Baldwin County Planning Commission Staff Report

Case No. PUD25-06 & SV25-11
County RD 55 RV Storage
July 10, 2025

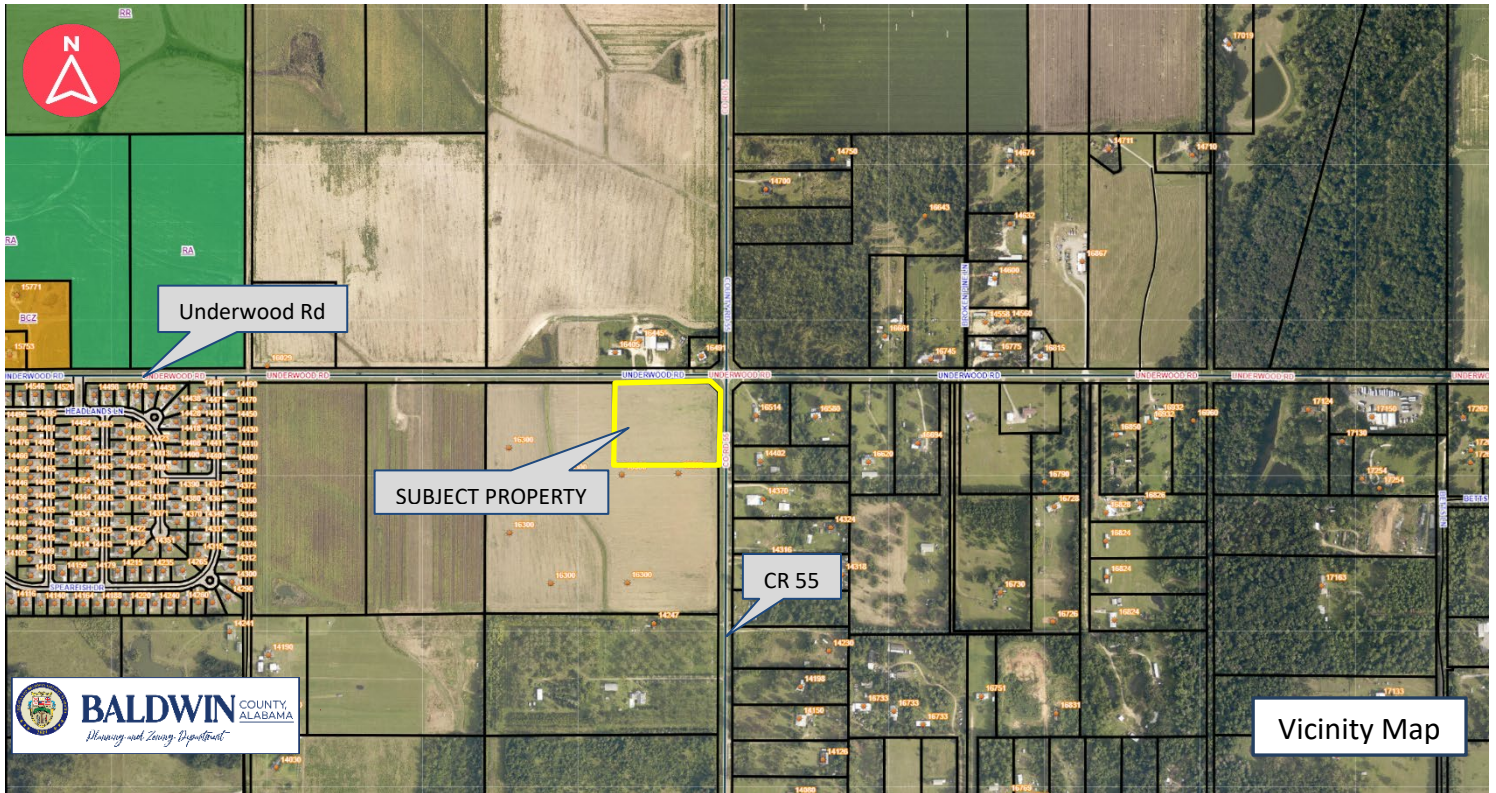
1. Add vicinity map to site plan
2. Show a 10' Landscape buffer along Underwood Rd.
